Dual signature state diagram parity to single signature state diagram comment.

NOTE: this comment is against State Diagrams that aren't in the D3.0 document. Looking at the published standard, this comment is against Figure 145-15 on document page 144, 145 and Figure 145-16 on document page 148, 149.

Figure 145–15—Primary Alternative dual-signature semi-independent PSE state diagram (continued)

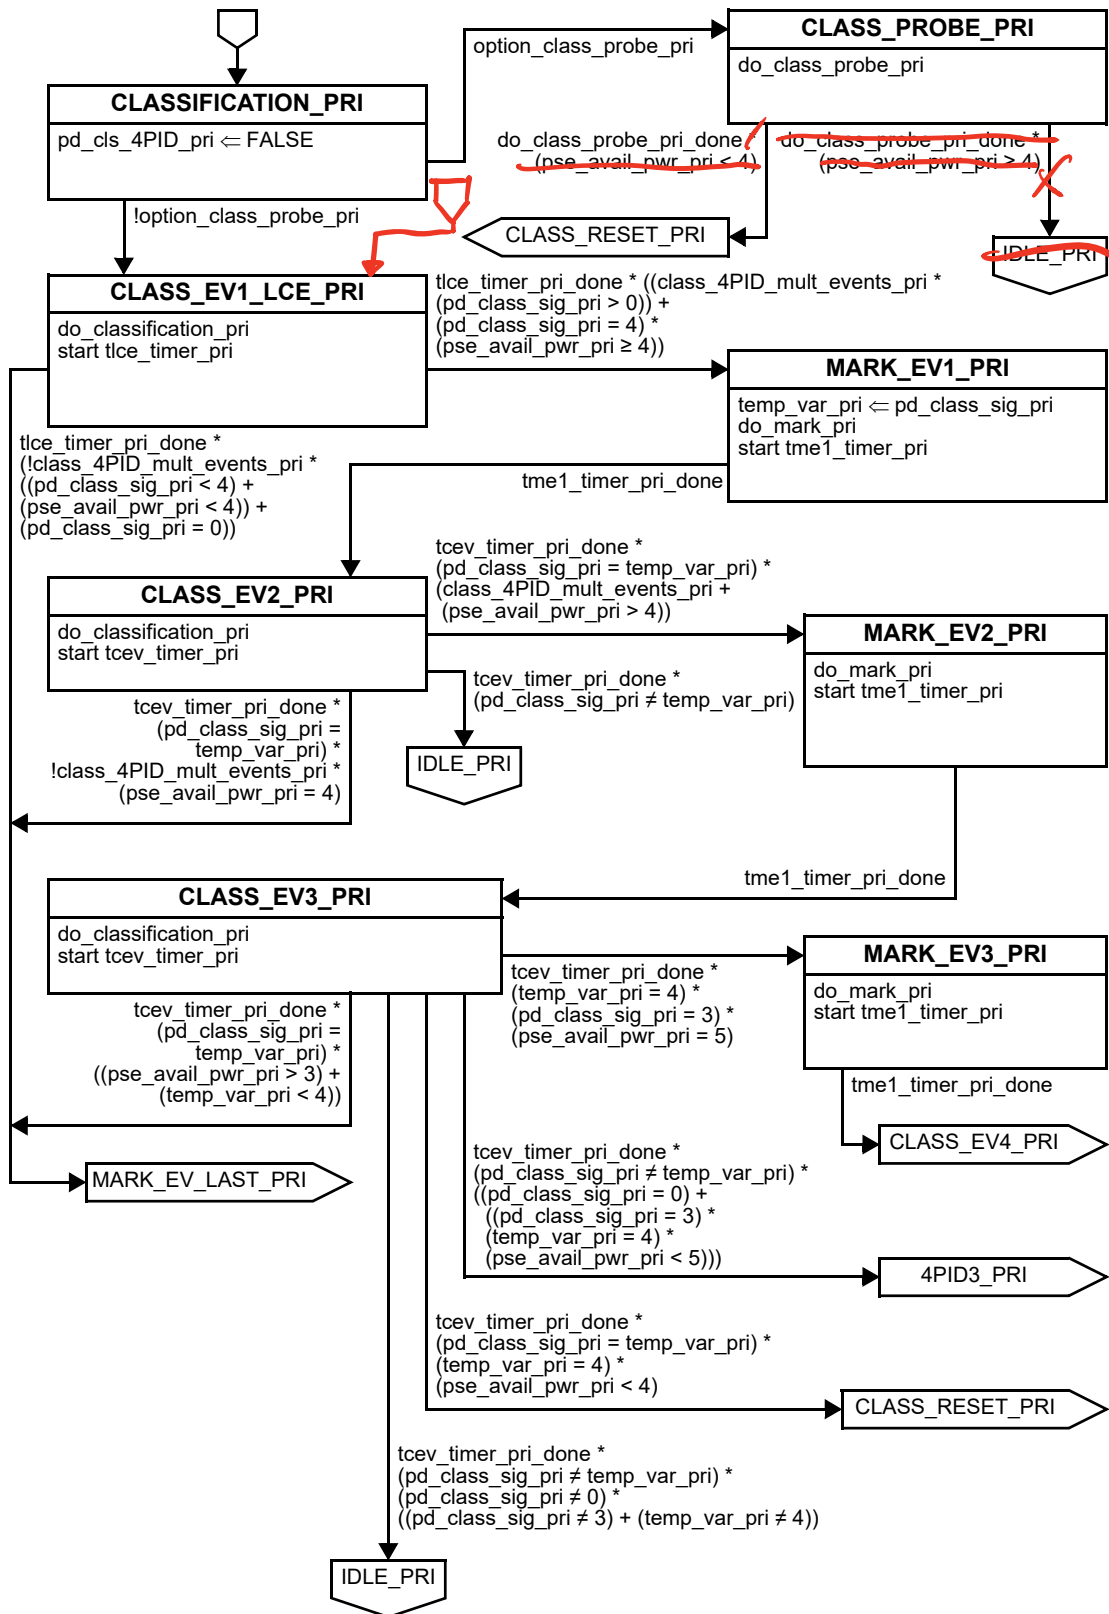
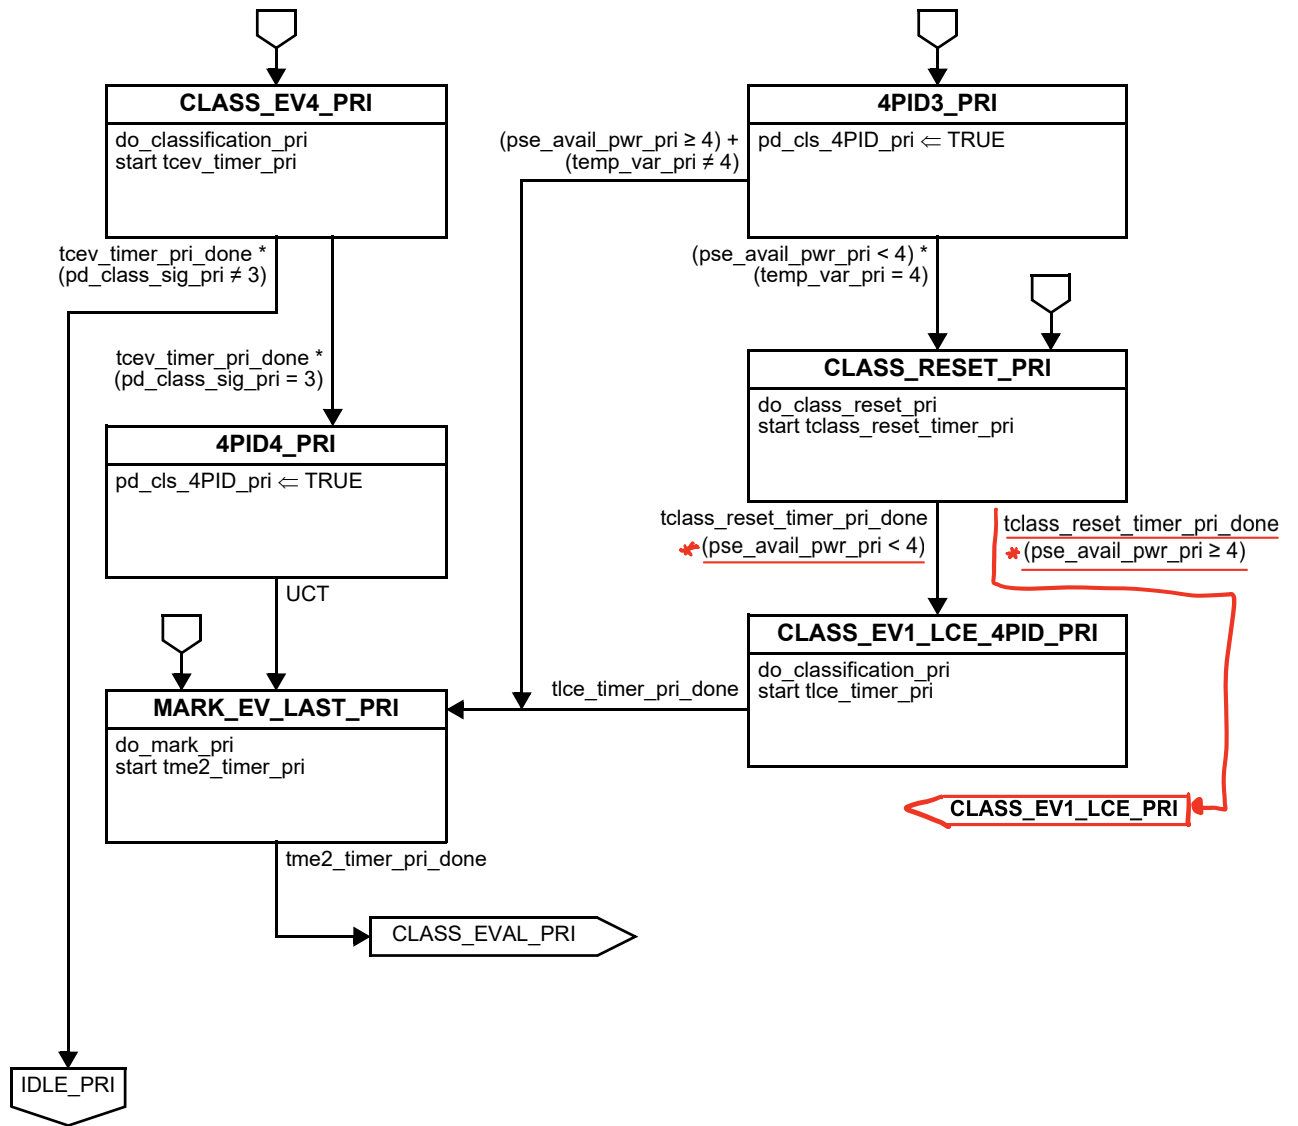
The single signature PSE state diagram (Figure 145-13) on page 139 allows the path from CLASSIFICATION to CLASS_PROBE to CLASS_RESET and to CLASS_EV1_LCE. This path allows a PSE to perform a class probe, perform a class reset and then immediately perform multi-event classification (without having to perform detection/CC).

Moving to the dual signature PSE state diagrams (we will talk only about the PRI diagram 145-15 since the SEC diagram is identical), at the top of page 144 we see the path is CLASSIFICATION_PRI to CLASS_PROBE_PRI. contrasting the SS SD, there are two paths out of CLASS_PROBE_PRI, and either allows the PSE to perform a class reset and then move to multi-event classification. One arc travels to CLASS_RESET_PRI, to CLASS_EV1_LCE_4PID_PRI, then to MARK_EV_LAST_PRI. Only one event is allowed in this case. If the PSE needs to perform multi-event classification, it must use the other arc back to IDLE_PRI which requires a new detection and CC. There is no technical justification to force the two PSEs 'flavors' to behave differently in this case. My comment will modify the dual signature state diagrams to allow multi-event classification immediately after a class probe.

the modification is shown against Figure 145-15, the same change will need made to Figure 145-16.

pg 144

delete the IDLE_PRI arc from CLASS_PROBE_PRI.

delete "*" (pse_avail_pwr_pri < 4)" from the arc to CLASS_RESET_PRI. [the only arc from CLASS_PROBE_PRI is to CLASS_RESET_PRI]

add an empty label arc into CLASS_EV1_LCE_PRI.

pg 145

add " * (pse_avail_pwr_pri < 4)" to the arc from CLASS_RESET_PRI to CLASS_EV1_LCE_4PID_PRI

add a new arc out to CLASS_RESET_PRI to CLASS_EV1_LCE_PRI with the exit condition:

"tclass_reset_timer_pri_done * (pse_avail_pwr_pri ≥ 4)"

perform same changes to Figure 145-16 on page 148, 149.
